CITY OF KENNEWICK HEARING EXAMINER
James M. Driscoll, Hearing Examiner

- A. Preliminary Plat (PP No. 21-03/PLN-2021-02726), "Washington Meadows" proposing to subdivide 4.2 acres into 18 lots. The site is generally located at 2109 S. Washington Street. The site is currently zoned Residential, Low Density (RL), the Comprehensive Plan designation is Low Density Residential. The applicant and property owner is Darrell Bussell, DDB, LLC, 6103 Balsam Court, West Richland, WA, 99352.
- B. Preliminary Plat (PP No. 21-02/PLN-2021-01979), "Crimson Hills" proposing to subdivide 14.76 acres into 138 lots. The site is generally located at 9757 W. Clearwater Avenue. The site is currently zoned Residential, Medium Density (RM), the Comprehensive Plan designation is Medium Density Residential. The applicant is Nathan Machiela, Knutzen Engineering, 5401 Ridgeline Drive, Suite 160, Kennewick, WA 99338. The property owner is Tom Solbrack, 2555 W Hwy 24, Othello, WA 99334.

COMMUNITY PLANNING DEPARTMENT
STAFF REPORT AND RECOMMENDATION TO
THE HEARING EXAMINER

FILE NO: PP 21-03 / PLN-2021-02726

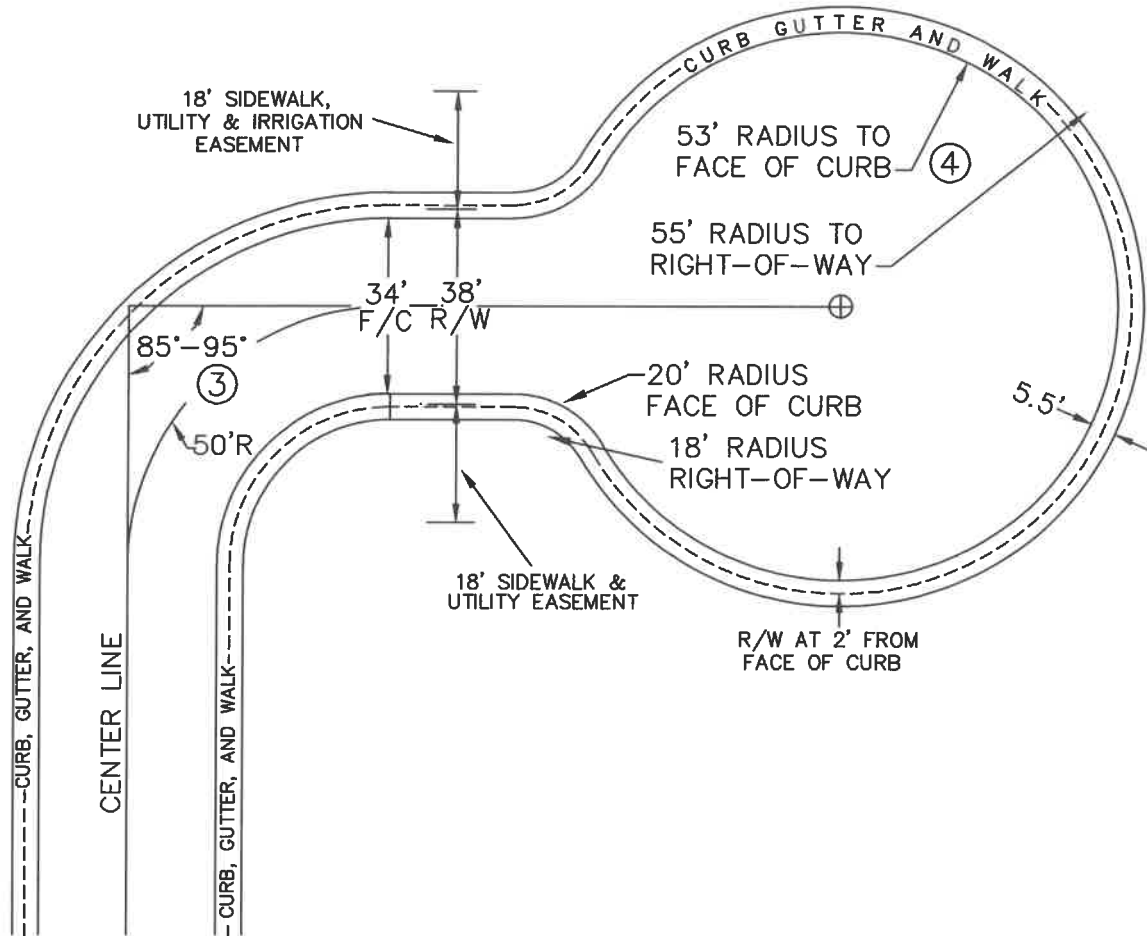
We are requesting a design standard waiver from a portion of the Standard Specification Dwg. NO. 2-1 SHEET 3 OF 4 CUL-DE-SAC on a proposed Preliminary Plat to be located at 2109 S Washington St.

Our request is to allow a reduction from the 18 ft. sidewalk, utility, irrigation easement to a 10 ft. sidewalk and utility easement at the northern portion of the cul-de-sac bulb on lots 7 and 8 as shown on the attached drawing. The standard easement of 18 ft. has been provided to lots 7 and 8 and then reduced to a width of 10 ft. around the bulb due to the proximity to the property line. We have also provided adequate area needed for the additional 18 inches required due to sidewalk placement adjacent to fencing.

name
**WASHINGTON MEADOWS SUBDIVISION
OVERALL UTILITY PLAN**

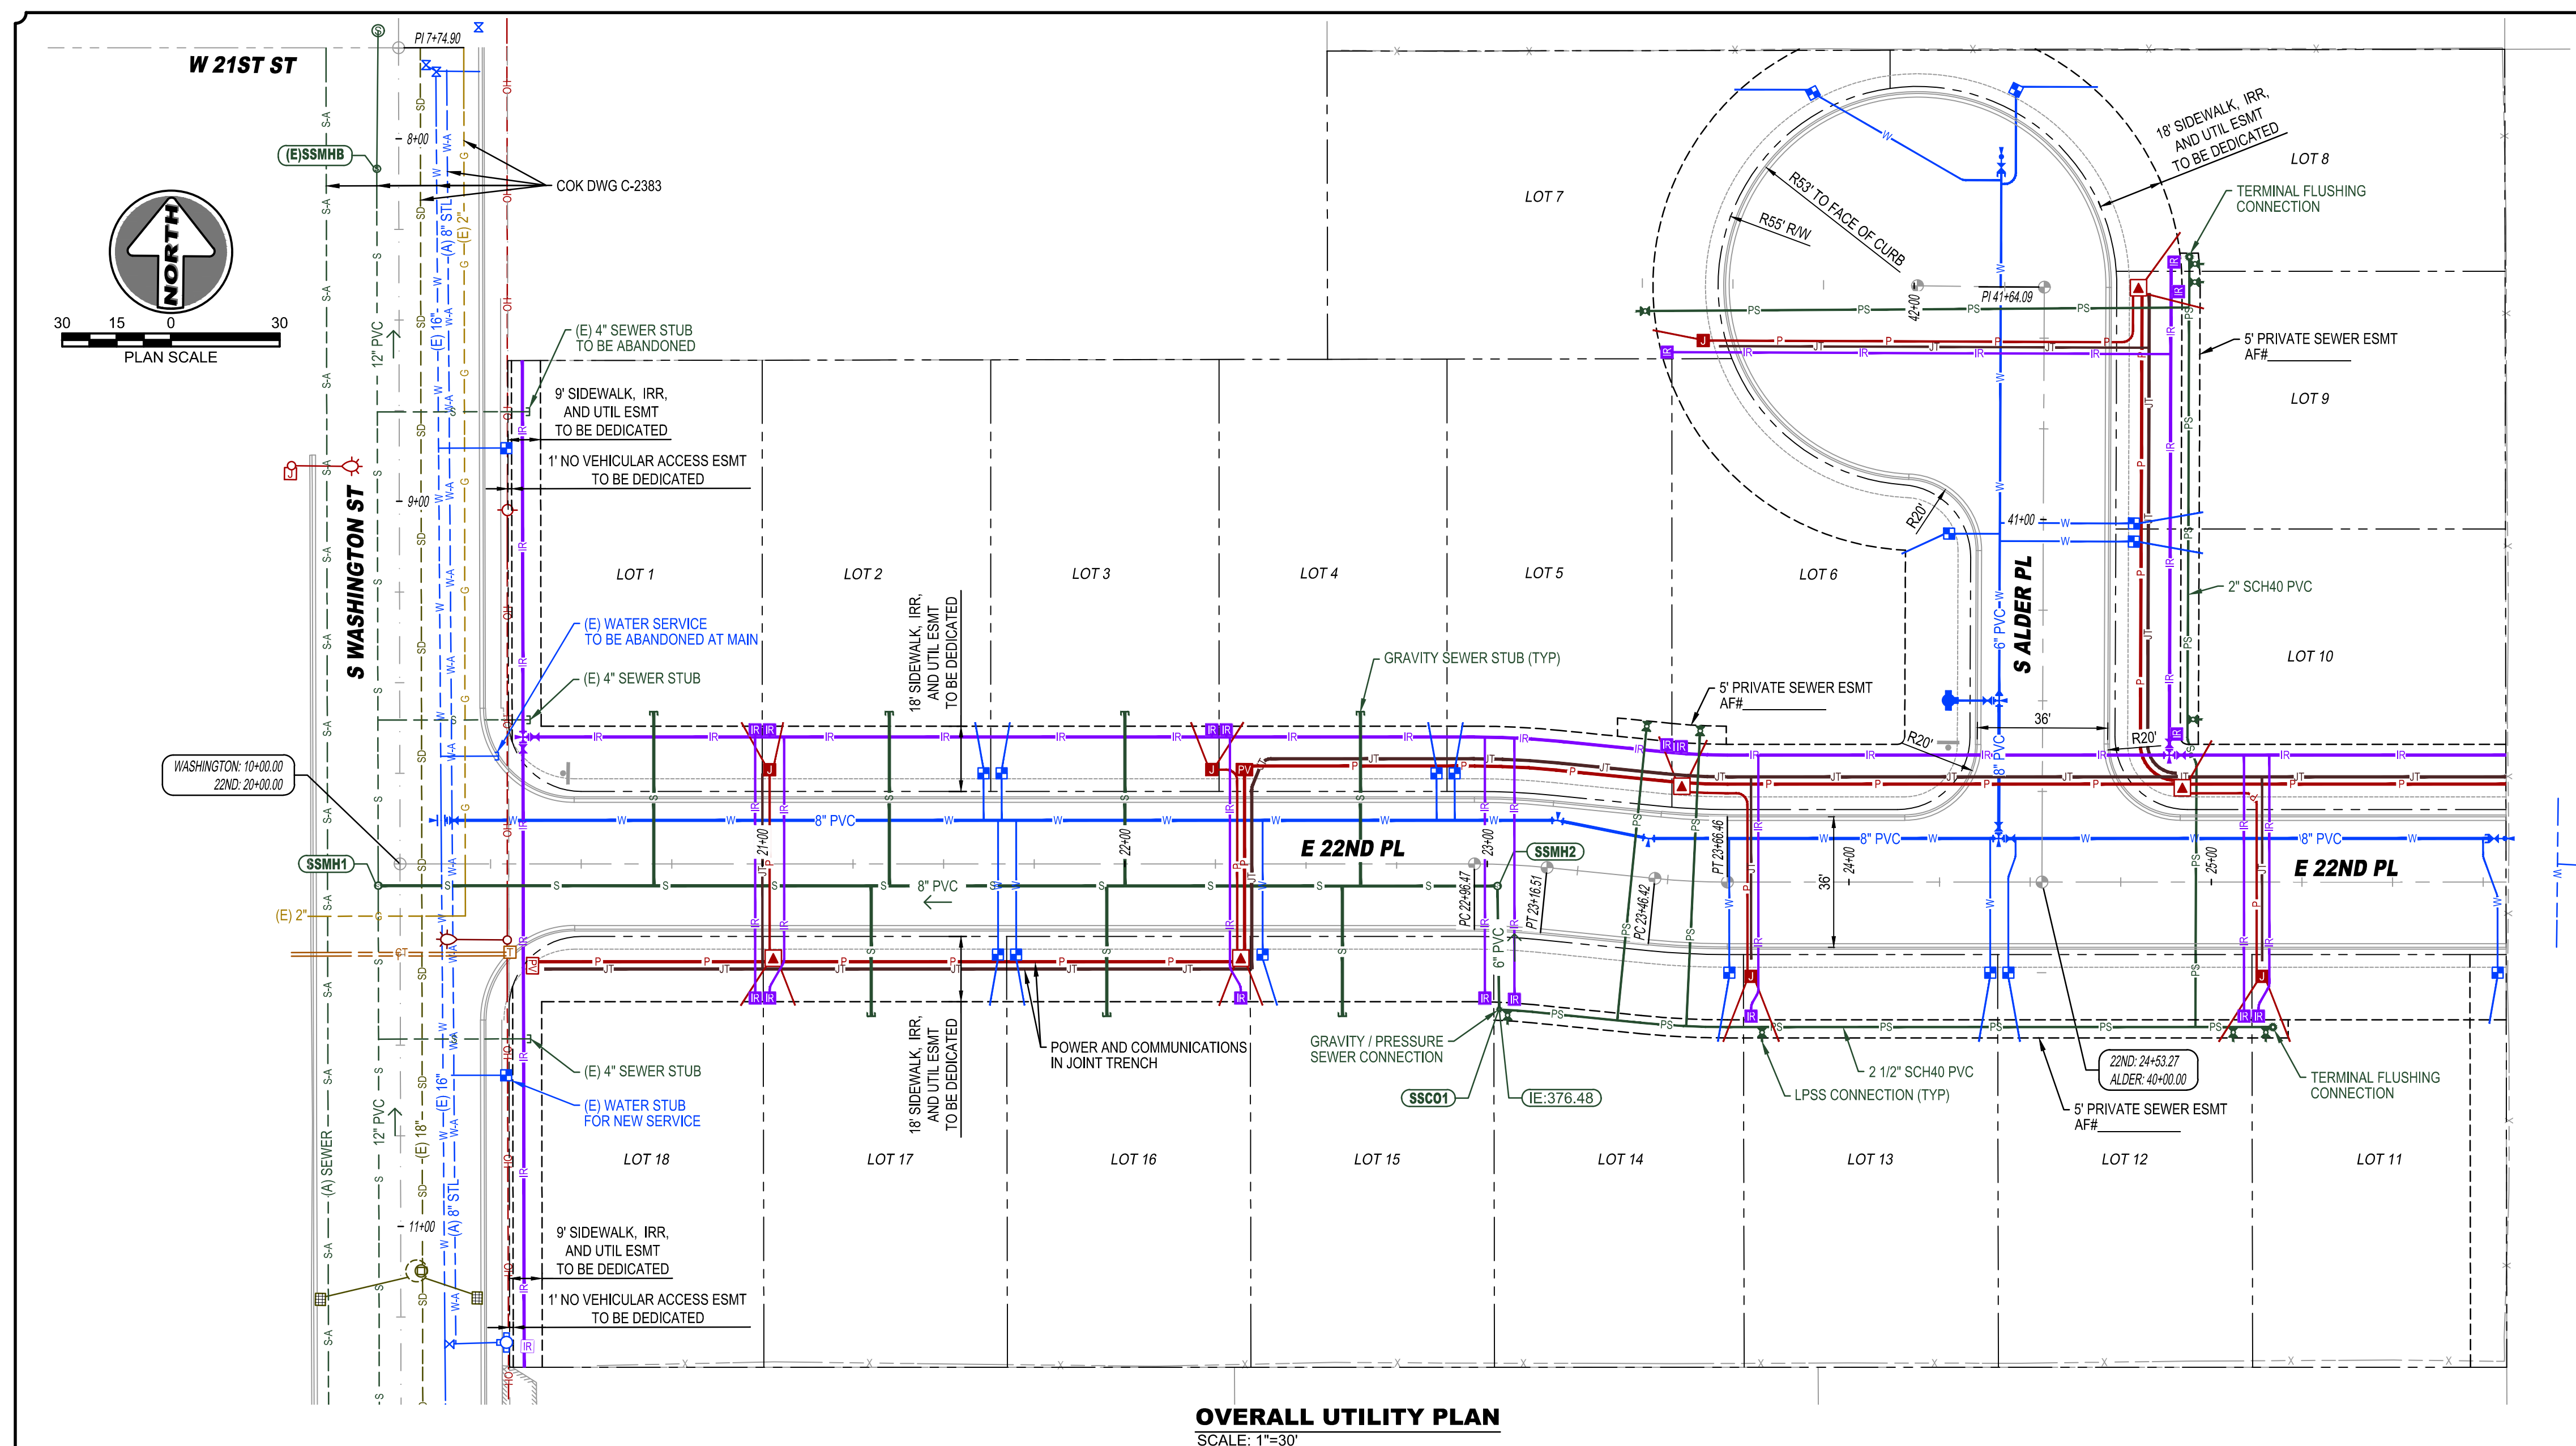
Per our conversation, attached is the overall utility plan that shows how we propose to route the utilities for the Washington Meadows subdivision. A full 18' wide easement for sidewalk, irrigation, and utilities is not needed around the bulb of the cul-de-sac.

You had also asked for a fire truck turning exhibit in the comments on the preliminary plat. We can get that to you, but we aren't sure it's necessary. The cul-de-sac meets or exceeds the dimensions shown on COK Std. Dwg. 2-1 sheet 3 of 4. Let me know if the attached exhibit which includes dimensions is sufficient or if you still need a fire truck turning exhibit.

Please note the attached plan does not yet include the curb ramps at the corners and street light location.

We are unable to get gravity sewer to the east side of the proposed development due to the sewer main invert elevation on Washington St. (374.5) and the elevations on the east side of the property (372), refer to preliminary E 22nd PI profile. Therefore, we would like to provide a private low pressure sewer system for the east side of the development. The attached utility layout shows the proposed routing for that along with the location of a 5' private sewer easement that would be recorded separately. This is similar to what we had to do for the Zintel Creek Estates project.

Could you please verify that this will be acceptable? Let me know if you need anything else.

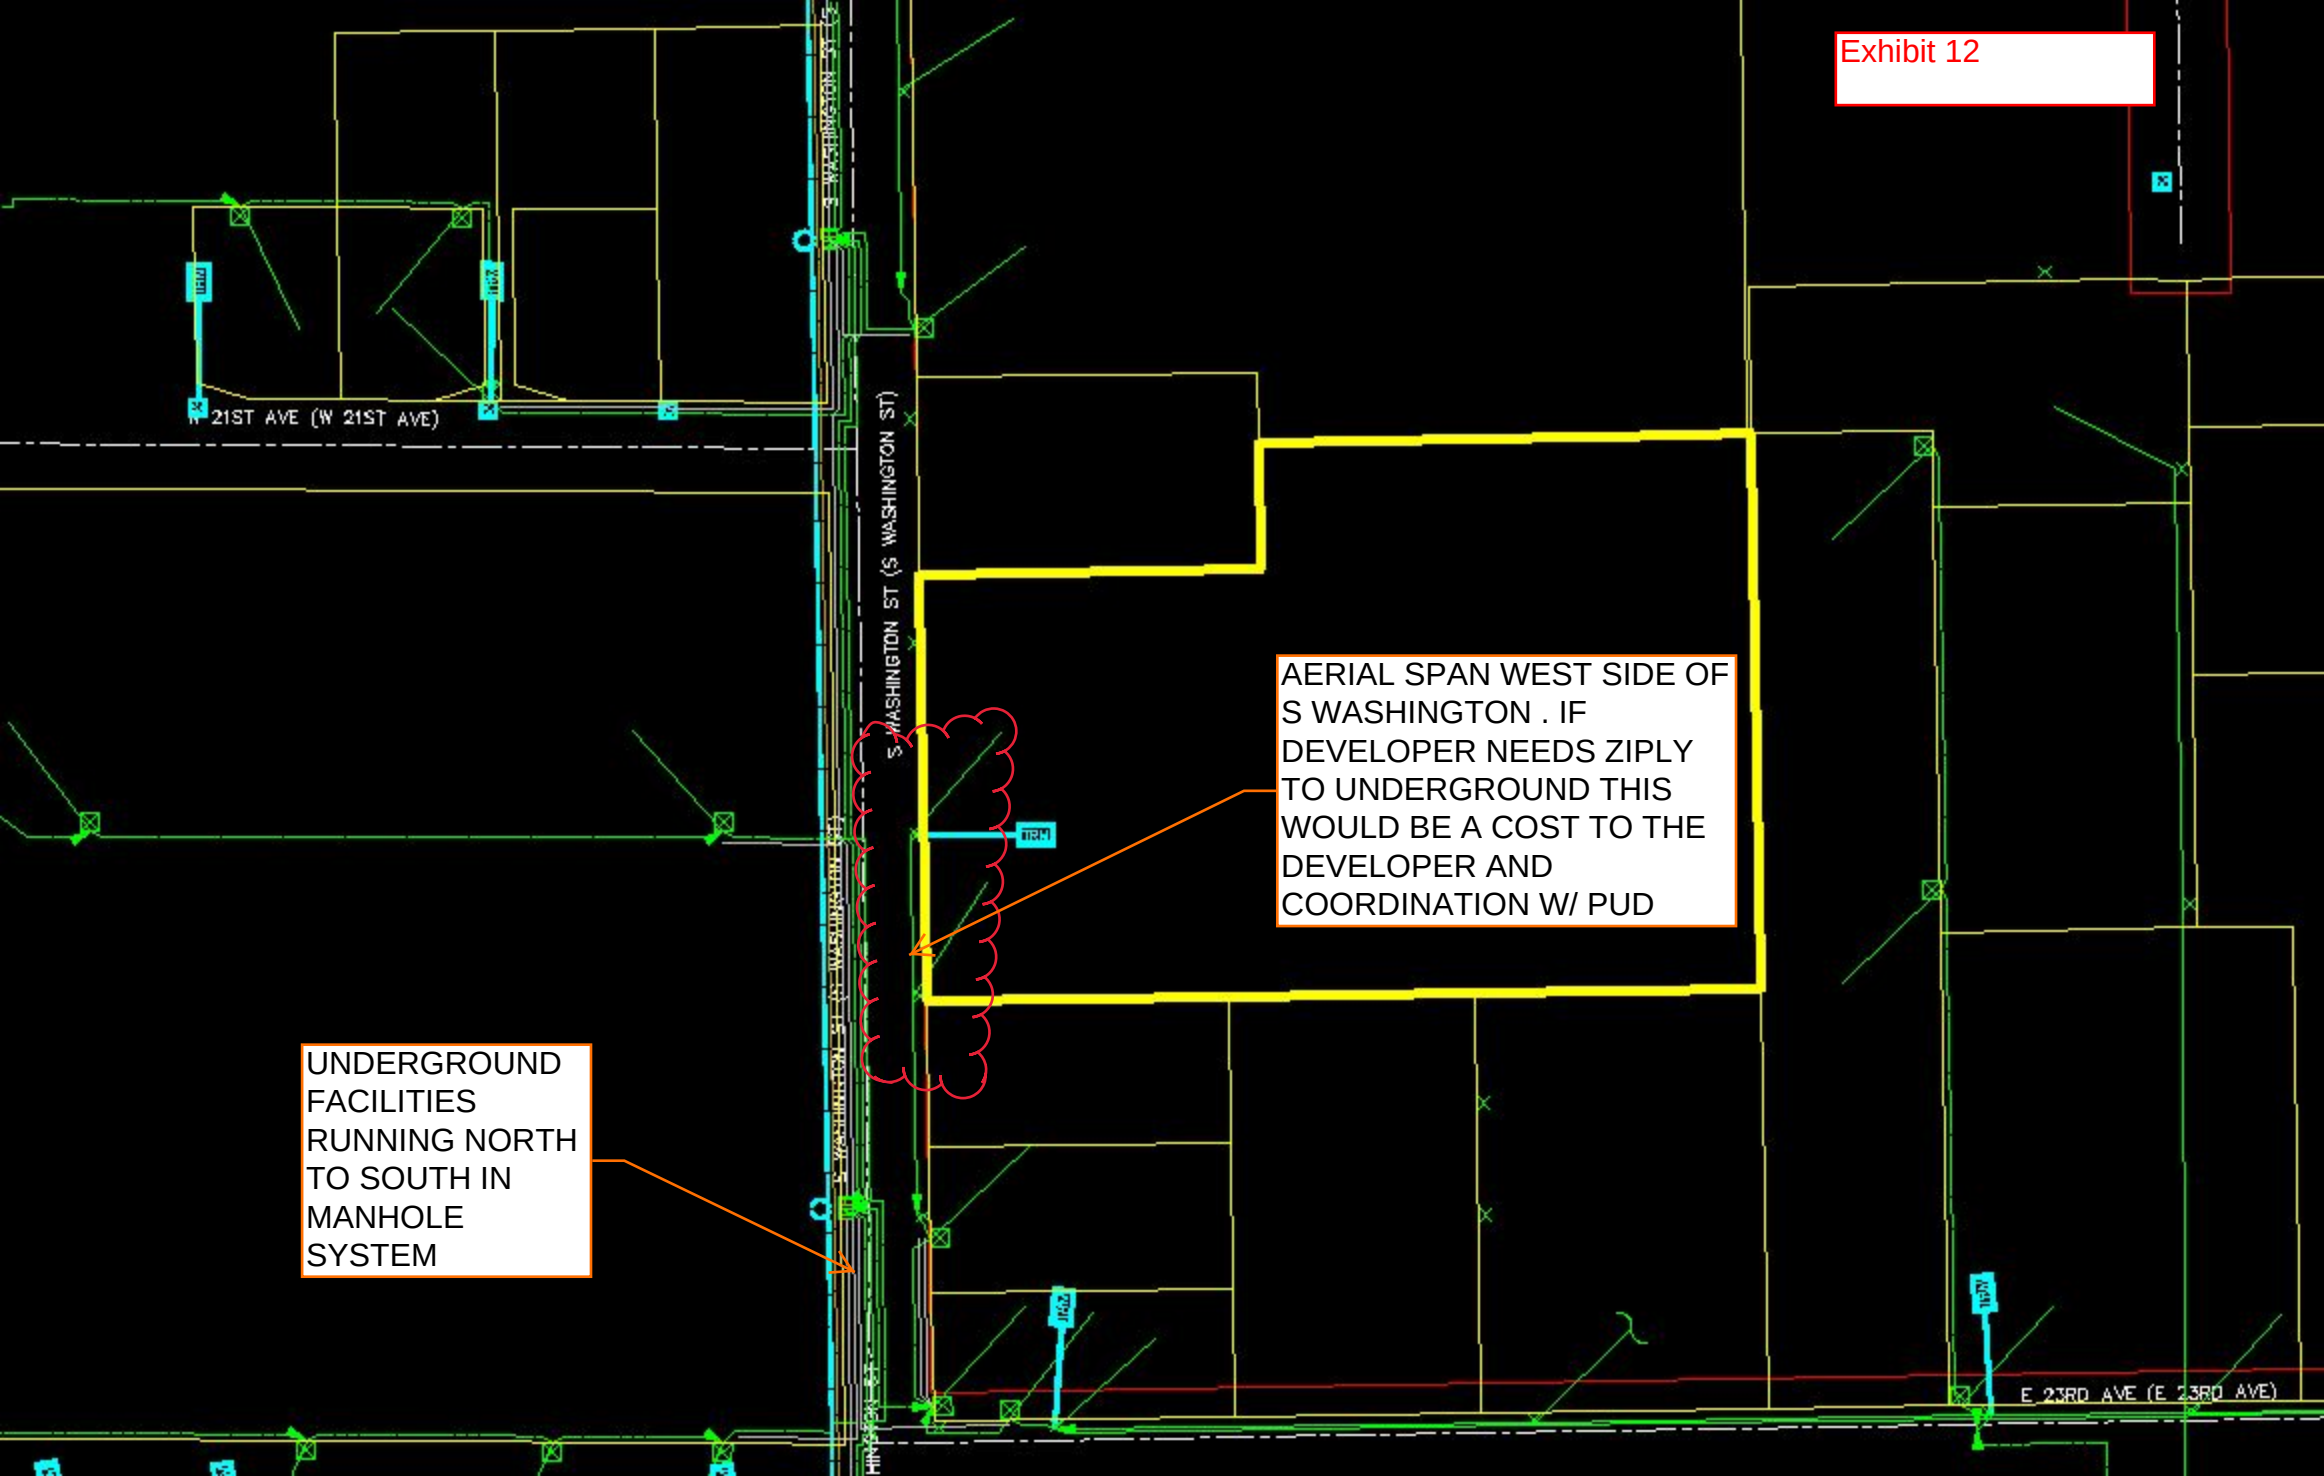
I have attached notes for this new subdivision. It shows Zply has an aerial section near the proposed road entrance on the power poles. The rest of Zply's facilities are all underground in the manhole system running along S Washington St.
